Title of Change:	Assembly and Test Transfer From AUK Dalian China to JCET Chuzhou China with Case outline change for SOT23FL products
Proposed First Ship date:	16 Mar 2021 or earlier if approved by customer
Contact Information:	Contact your local ON Semiconductor Sales Office or albert.reyes@onsemi.com
PCN Samples Contact:	Contact your local ON Semiconductor Sales Office or < PCN.samples@onsemi.com >. Sample requests are to be submitted no later than 30 days from the date of first notification, Initial PCN or Final PCN, for this change. Samples delivery timing will be subject to request date, sample quantity and special customer packing/label requirements.
Additional Reliability Data:	Contact your local ON Semiconductor Sales Office or Lalan.Ortega@onsemi.com
Type of Notification:	This is a Final Product/Process Change Notification (FPCN) sent to customers. FPCNs are issued 90 days prior to implementation of the change. ON Semiconductor will consider this change accepted, unless an inquiry is made in writing within 30 days of delivery of this notice. To do so, contact PCN.Support@onsemi.com

Final Product/Process Change Notification

Document #:FPCN23465X

AUK Dalian – Before Change

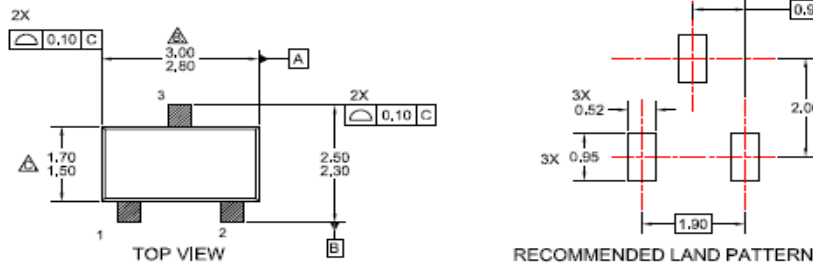
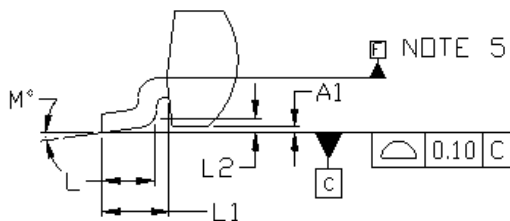
As indicated above, this transfer includes a change from the current case outline, or package outline drawing. The images below are provided for convenience and review. These packages have compatible solder landing patterns.

AUK Dalian – Before Change

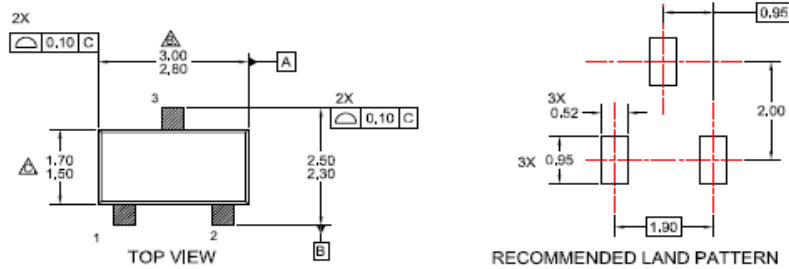
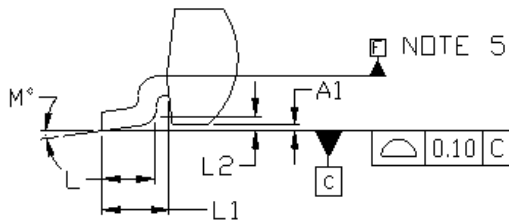
変更前の表記	変更後の表記																											
リードフレーム	PMC90 Ag STAMPED	A194 stamped																											
ダイ接着剤	Exbond 8280C	Henkel DA 84-1																											
モールドコンパウンド	KCC KTMC1050GR	EDALE ELER 8100HFE																											
組立拠点	AUK-Dalian	JCET Chuzhou																											
検査拠点	AUK-Dalian	JCET Chuzhou																											
ケースアウトライン	419BD	以下に図示します。																											
	From	To																											
製品マーキング変更	XXXX 場所: XXX: 製品マーキング	XXXXM 場所: XXXX: 製品マーキング M: 日付コードおよび製造拠点																											
<p>上記のように、本移管には現行のケースアウトライン、またはパッケージ外形図からの変更が含まれます。以下の図を参照してください。これらのパッケージのはんだランドパターンは互換性があります。</p>
